AA PROJECT # 1001989

ADMINISTRATIVE AMENDMENT
 FILE # 10-10113 PROJECT # 1001989
remove decel lane + bus shelter;
bring walls up to code
 APPROVED BY *Marion* DATE *9/22/10*

SITE PLAN FOR SUBDIVISION

A PROPOSED PLAN FOR
COORS PARK & SELL
 (COORS BLVD. N.W. AND FORTUNA RD. N.W.)
 ALBUQUERQUE, NEW MEXICO

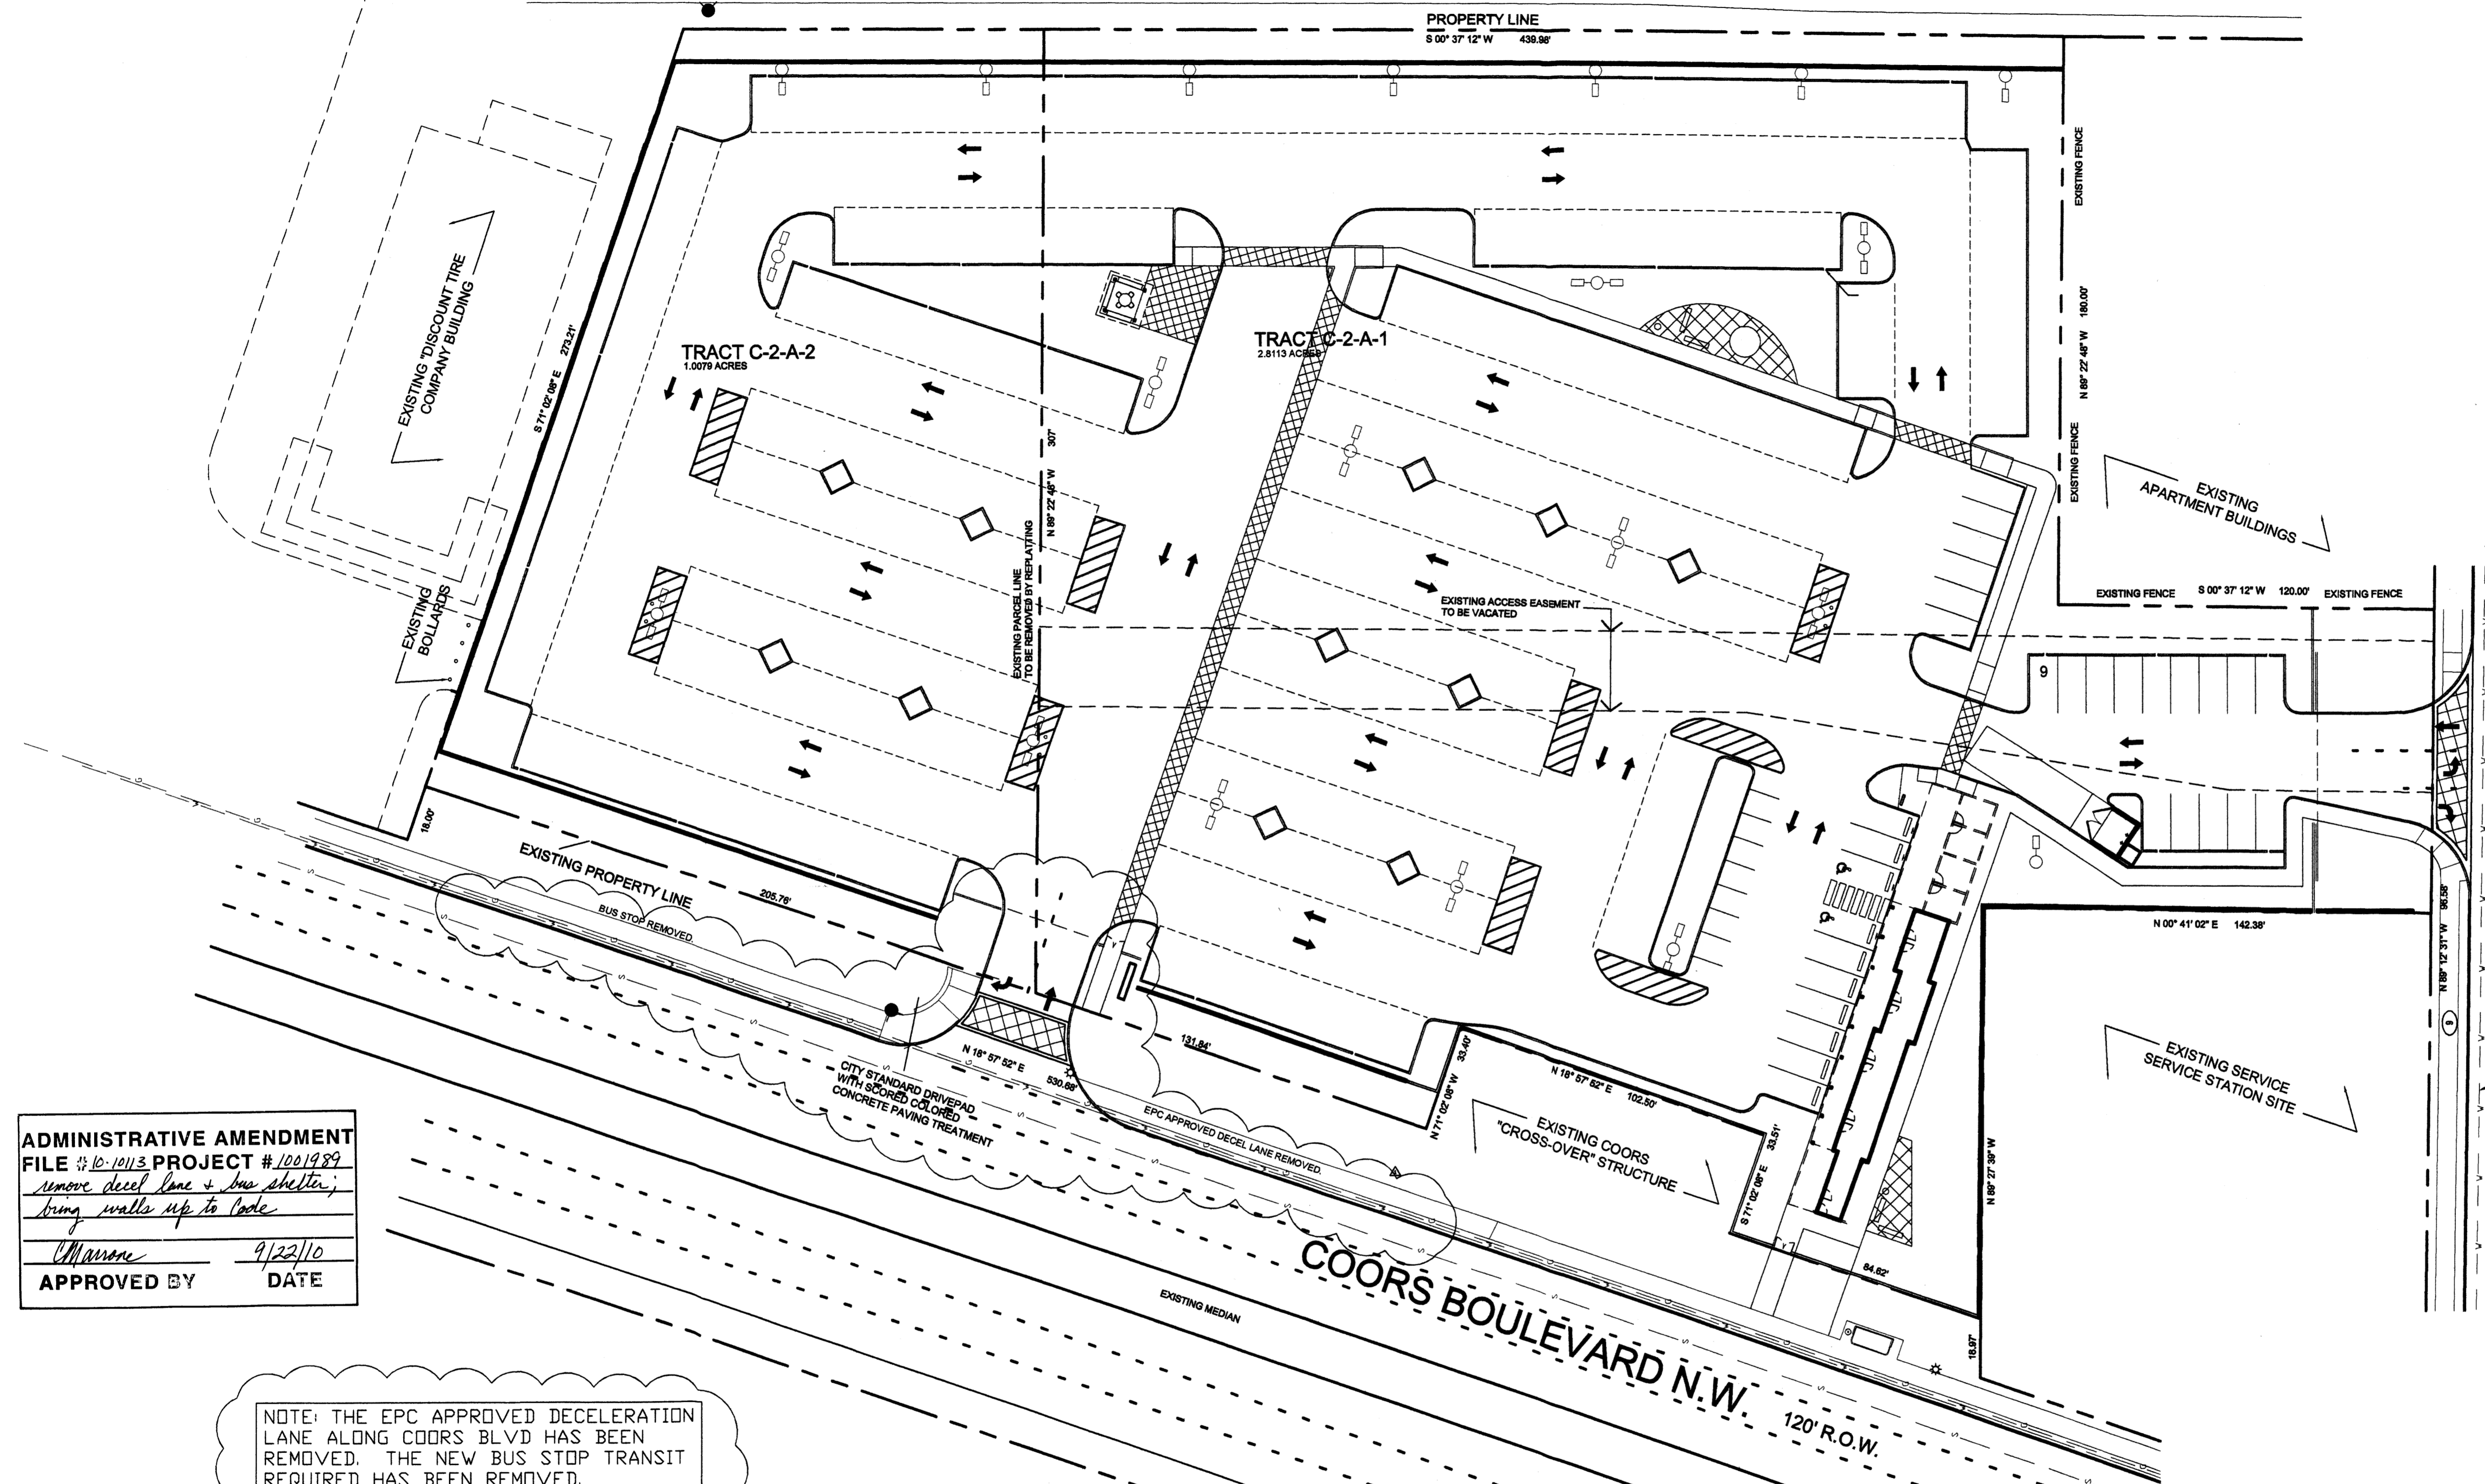
NOTE: THE EPC APPROVED DECELERATION LANE ALONG COORS BLVD HAS BEEN REMOVED. THE NEW BUS STOP TRANSIT REQUIRED HAS BEEN REMOVED.

THE REQUIREMENT FOR A RIGHT TURN DECELERATION LANE, LOCATED AT THE APPROVED RIGHT TURN-IN RIGHT TURN-OUT SITE ACCESS ON COORS BOULEVARD, IS BASED ON THE CRITERIA AS IDENTIFIED IN THE CITY'S DEVELOPMENT PROCESS MANUAL (DPM). THE CURRENT LAND USE FOR THE SITE (I.E. AUTOMOBILE PARK AND SELL) DOES NOT GENERATE THE NUMBER OF ENTERING TRIPS, ASSIGNED TO THIS SITE DRIVE DURING EITHER AM OR PM PEAK HOUR, TO MEET THIS CRITERIA. HOWEVER, SHOULD THE LAND USE CHANGE, TH APPLICANT SHALL BE SUBJECT TO RE-EVALUATION, AS DETERMINED BY THE TRAFFIC ENGINEER, TO ESTABLISH WHETHER A RIGHT TURN DECELERATION LANE WOULD BE REQUIRED FOR THE NEW LAND USE PROPOSAL.
